65 HUNTINGWOOD DRIVE, HUNTINGWOOD – TRAFFIC RESPONSE TO SUBMISSIONS

The Department of Planning Industry and Environment (DPIE) and Transport for New South Wales (TfNSW) have raised traffic and transport-related concerns regarding the expansion of the existing processing facility located at 65 Huntingwood Drive Huntingwood.

Temporary car parking arrangements during Construction Stage 1

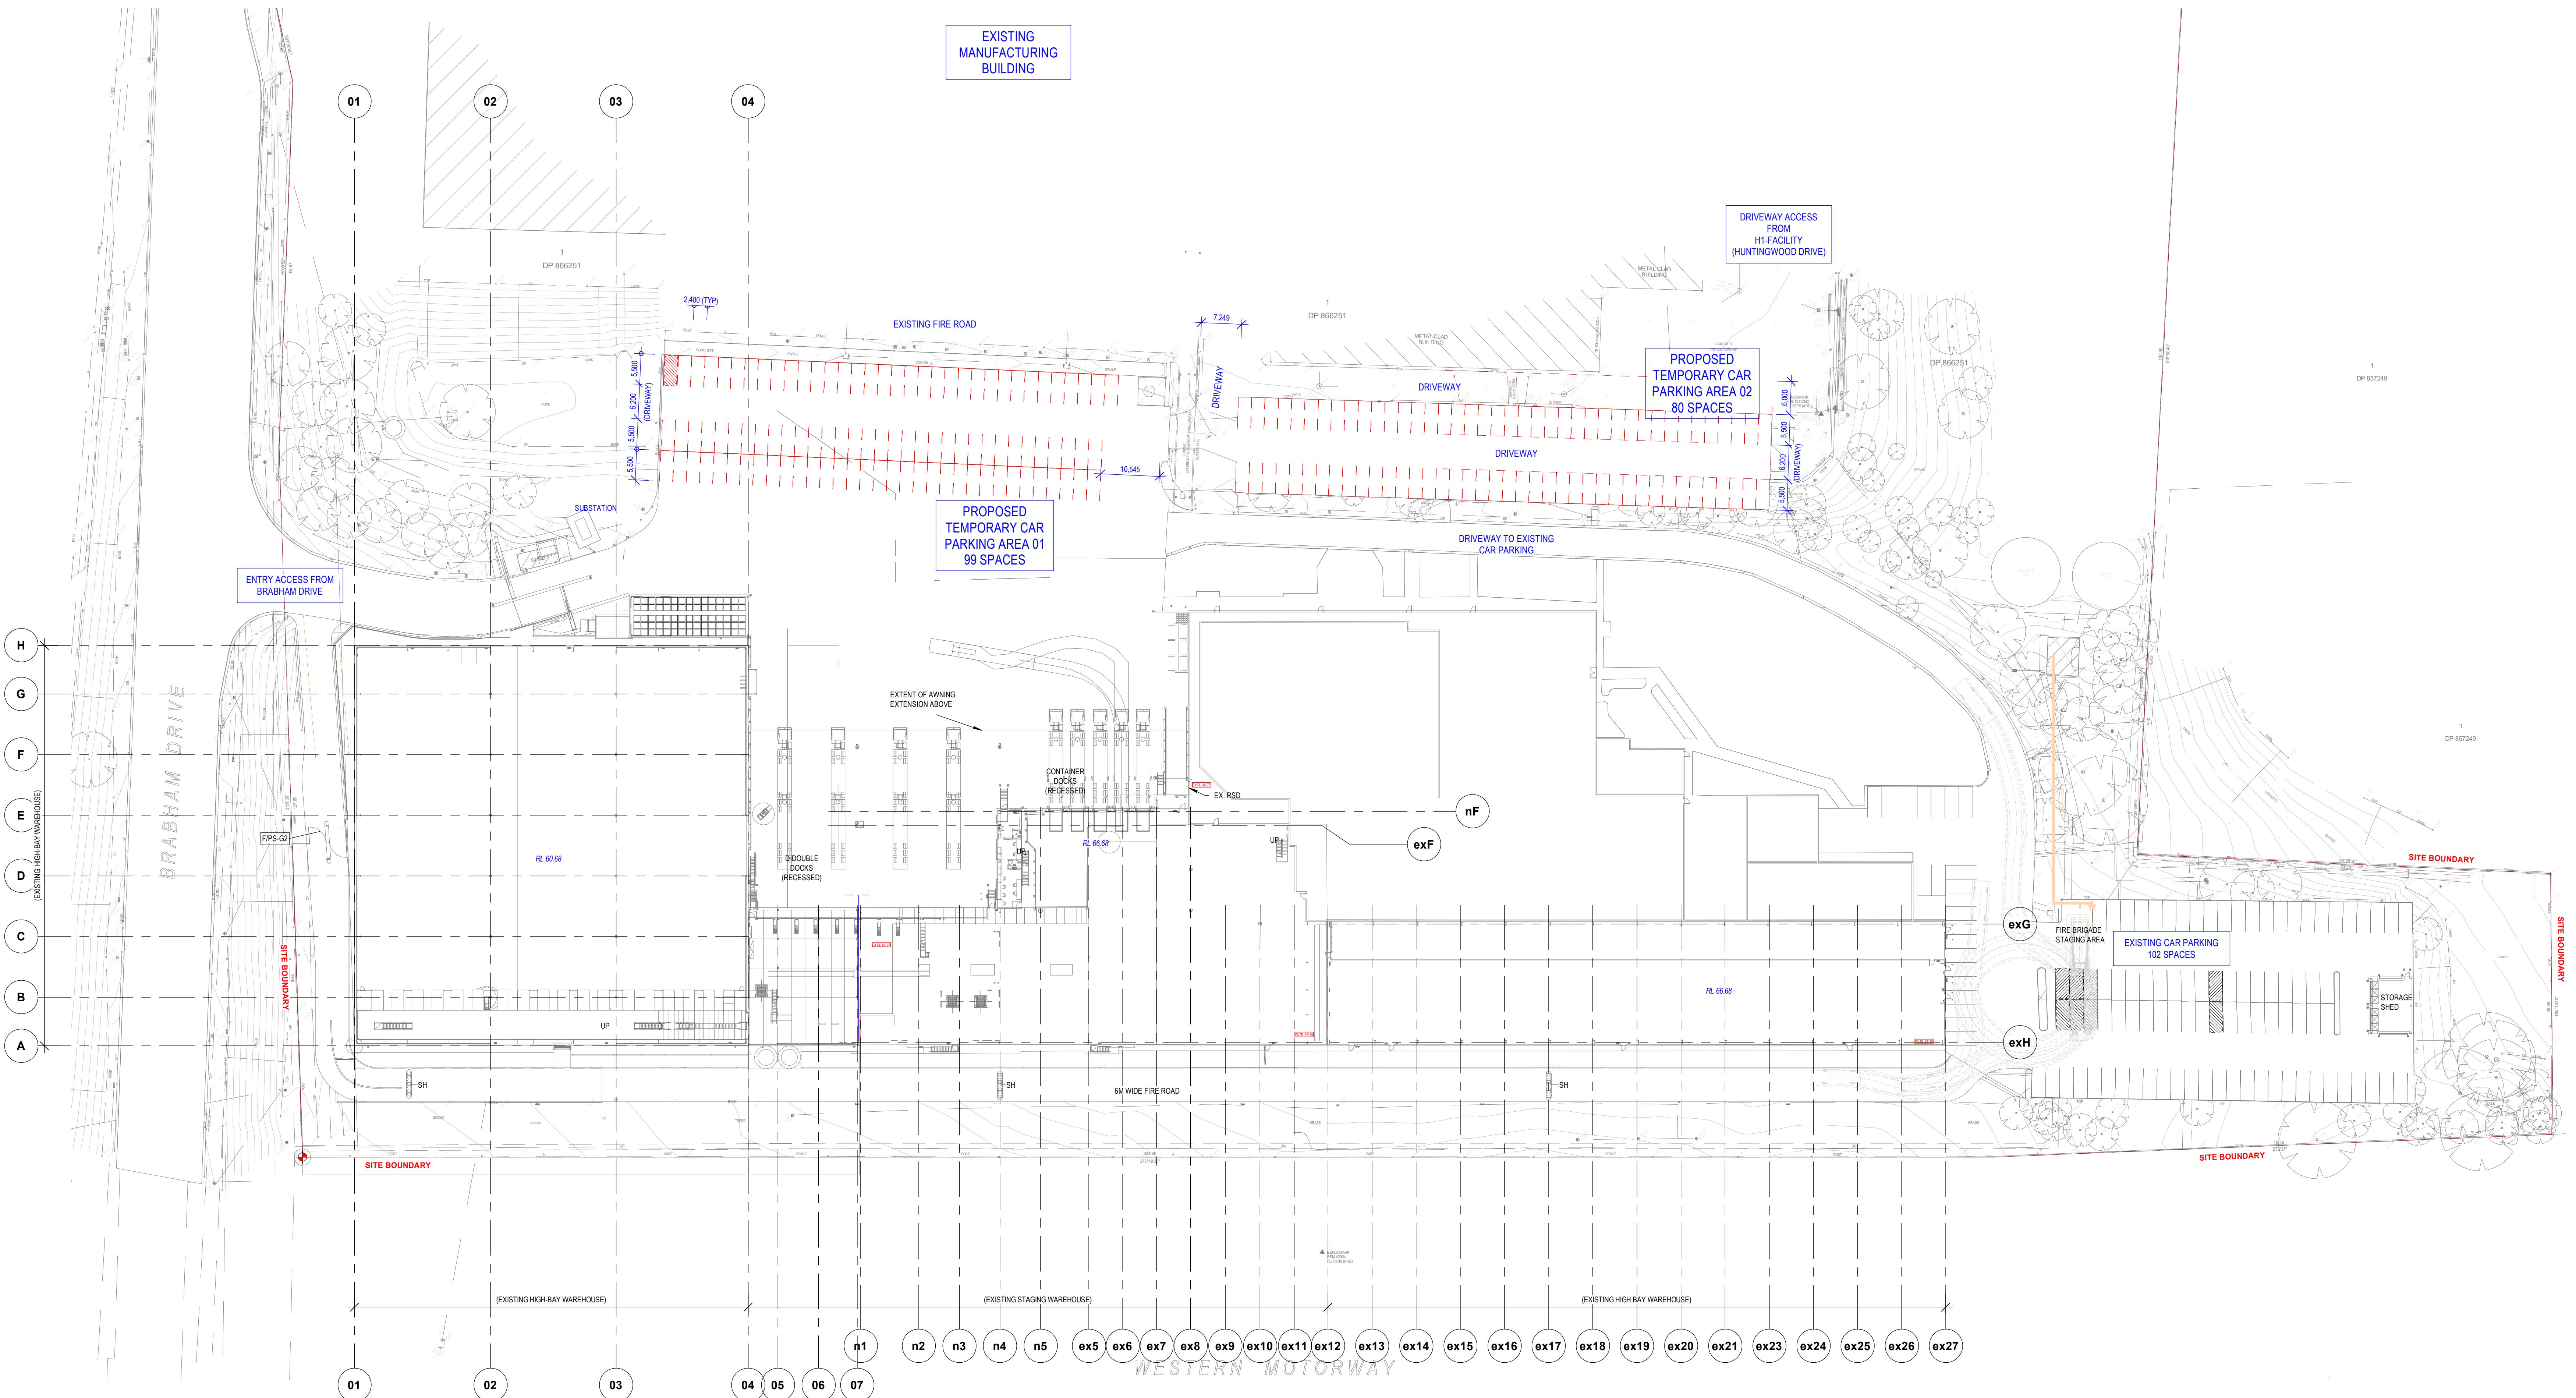
5. *According to the construction staging plan, the existing staff car park would become unavailable during construction. Further parking study should be required to identify the potential parking shortfall during construction.*

Urbis response – Temporary car parking arrangements during construction is detailed in Section 3.3 and 3.4 of the TIA prepared by Urbis.

Peak car parking demand for the site for staff during construction will be:

- 323 if all staff drove.
- 290 if the current mode share (90 per cent) found in Section 2.4 of the TIA is applied.

Details as to whether the temporary parking arrangements can support the peak parking demand are outlined below:

- During the site remediation phase and Construction Stage 2, there will be sufficient car parking to support the maximum car parking demand in both peak scenarios listed above.
- During Construction Stage 1, there will be 281 car parking spaces available for staff to use (refer temporary parking layout provided at **Appendix B**) if car usage is assumed to be in line with the current mode share. **Appendix B** will be assessed against relevant council guidelines and Australian Standards prior to the issue of a construction certificate.
- Additional demand for spaces can be managed through the use of staggered arrival times during Construction Stage 1.
- The peak demand of 290 car parking spaces will not be for a long period of time, once staff members depart after the completion of a shift, demand is significantly reduced.
